# Access Compliance Report Public Rights-of-Way (Curb Ramps)

Main Street: N/A Cross Street: CREIGHTON\_DR Location: S

ADA ID: RPRK211026141720 Ramp Type: Type 4 - Parallel Initial Pass/Fail: Fail Overall Compliance: No Severity Score: 2

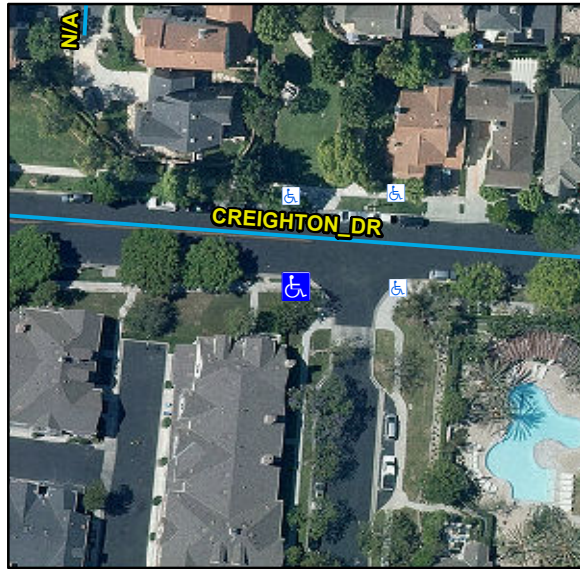
| Compliance | Description                   | Data       | Compliance | Description                   | Data |
|------------|-------------------------------|------------|------------|-------------------------------|------|
| No         | Ramp Cross Slope LT (%)       | 3.2        | Yes        | Ramp Cross Slope RT (%)       | 0.4  |
| N/A        | Gutter Ponding                | N/A        | No         | Curb Slope                    | 16.8 |
| N/A        | Gutter Cross Slope (%)        | N/A        | No         | Perpendicular Joint Present   | No   |

**Remove & Replace Curb Ramp With Two New Directional Ramps or Equivalent.**

**R304.2.2, R204.3, R304.5.3, STD 1115**
